Leigh Flood Storage Area Review

Independent audit of operation in the
December 2013 flood

MCR5376-RT001-R04-00

July 2015

Figure 4.4: Water surface area (Hectares) calculated from RBS volumes

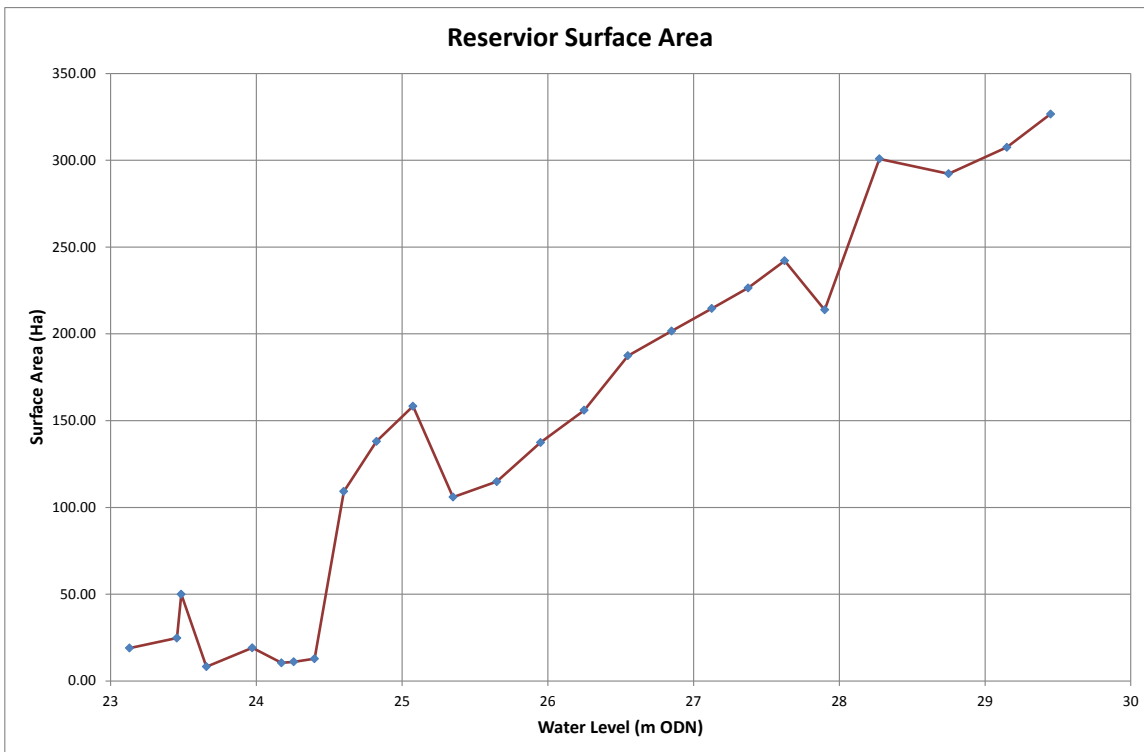
The volume data in the RBS increases in all cases as water level increases as is required. However, the water surface area is seen to decrease as water level rises at several places including about 0.5 m above the point of impoundment (water level 24.70 m) and just below the maximum operating level (28.05 m). Such a decrease in area as level rises is not realistic for an open watercourse and flood plain.

The basis of the stored volumes in the RBS must be reviewed to ensure that surface area of the storage reservoir is represented as increasing with water level. The basis of the revision could be the recent (2014) survey, coupled with appropriate assumptions on water surface gradient as the water level in the FSA rises. Alternatively, a more comprehensive investigation of the hydrodynamics of the filling of the reservoir could be undertaken before a revised operational model is derived for the RBS calculations.
